Lanier Dam (VA-08910), Roanoke River Basin.

Henry County
Virginia, Phase I
Inspection Report

NAME OF DAM: LANIER DAM
LOCATION: MARTINSVILLE CITY, VIRGINIA
INVENTORY NUMBER: VA 08910

PHASE I INSPECTION REPORT
NATIONAL DAM SAFETY PROGRAM

LANIER DAM
HENRY COUNTY, VA.
12 DEC. 1979
NOT TO SCALE
PLATE II

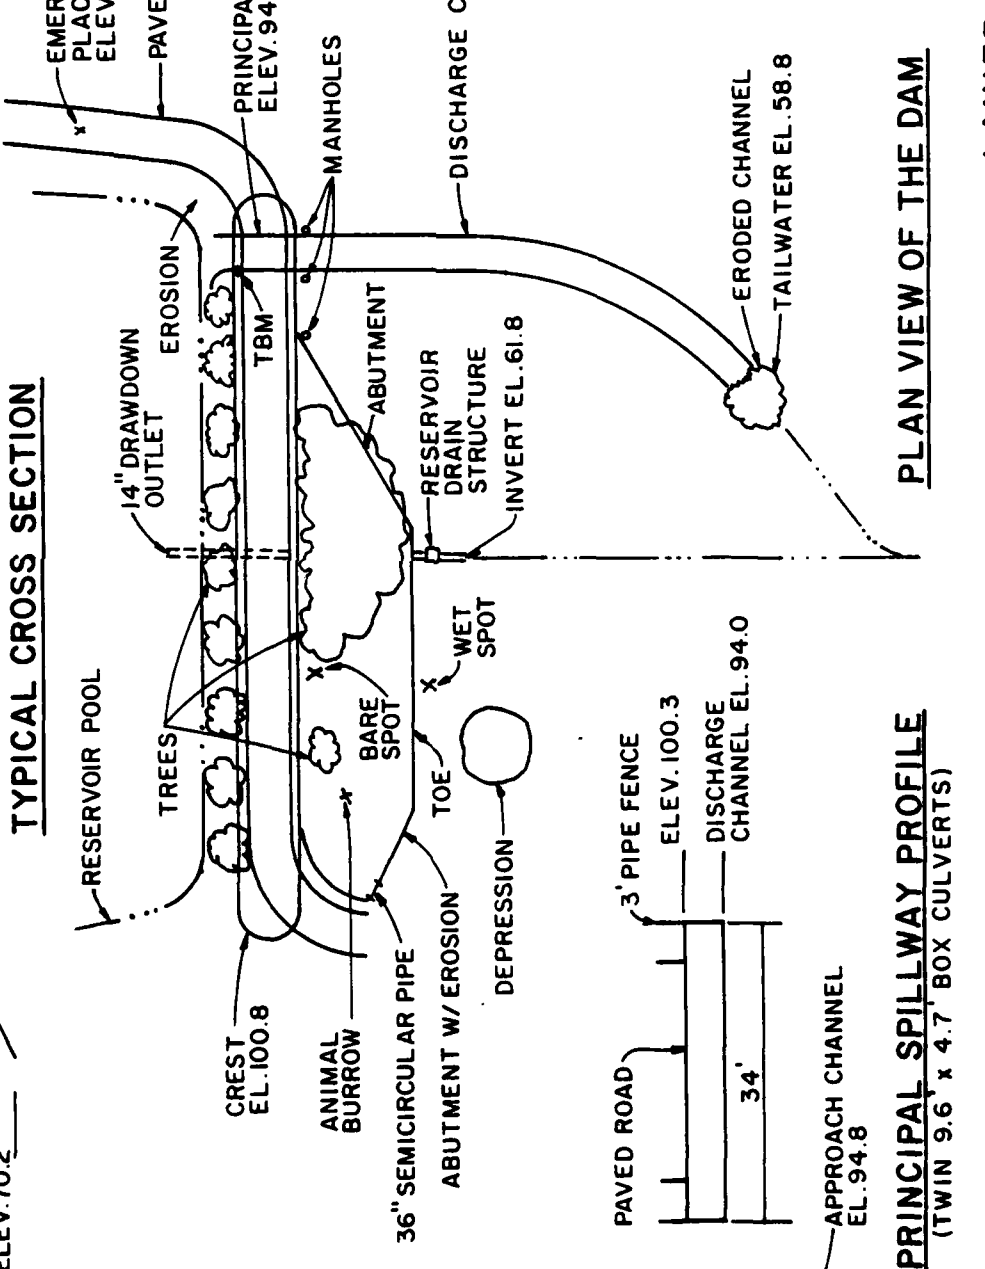
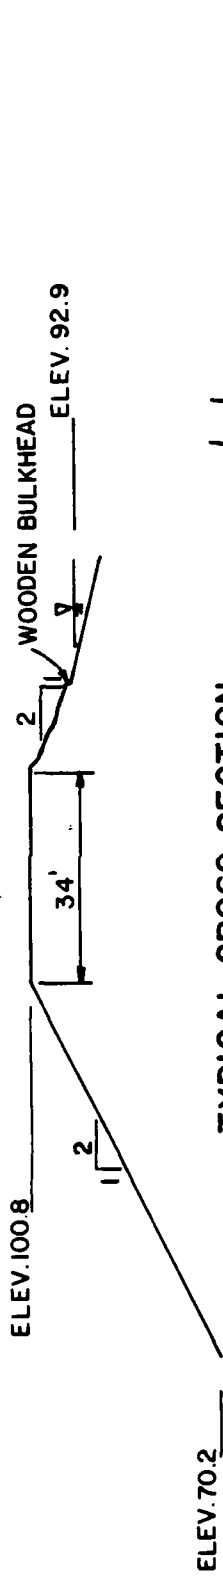
There is a wet spot in the downstream area at the toe of the embankment, a bare spot and an animal burrow on the downstream slope, all as located on Plate II. The wet spot is as shown in Photo 5 and the animal burrow in Photo 4.

d. The bare spot noted on Plate II should be reseeded.

e. The animal burrow, noted in Plate II, should be backfilled with compacted fill and seeded.

f. The wet spot noted on Plate II should be monitored for seepage or boils during a regular maintenance program. Should seepage occur, a professional geotechnical engineer should be consulted.

d. The bare spot noted on Plate II should be reseeded.

e. The animal burrow, noted on Plate II, should be backfilled with compacted fill and seeded.

f. The wet spot noted on Plate II should be monitored for seepage or boils during a regular maintenance program. Should seepage occur, a professional geotechnical engineer should be consulted.

PHOTO # 5 : RESERVOIR DRAIN STRUCTURE
& WET MARSHY AREA AT TOE

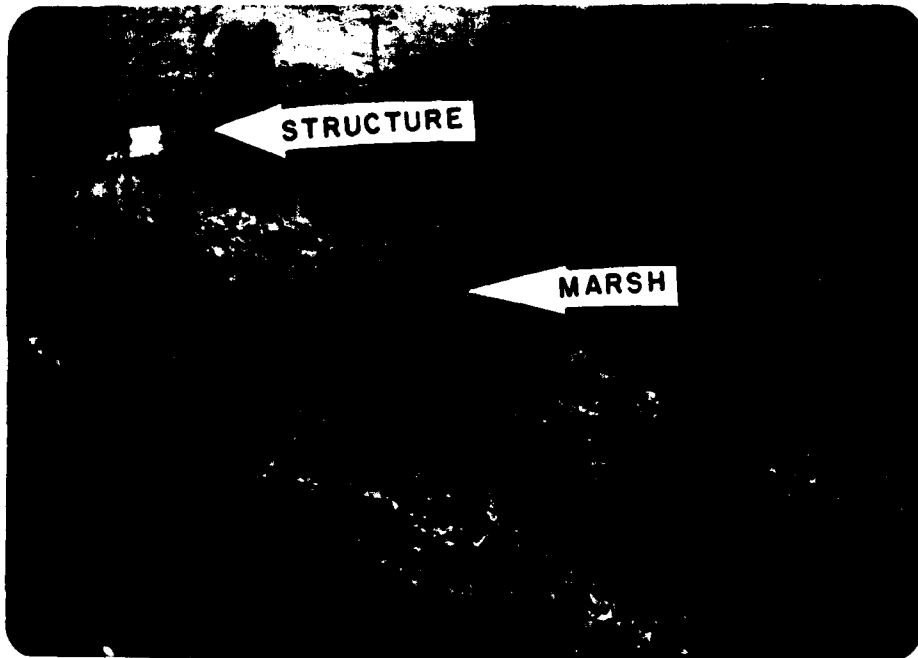
h. The reservoir drain structure should be locked to discourage vandalism.

h. The reservoir drain structure should be locked to discourage vandalism.
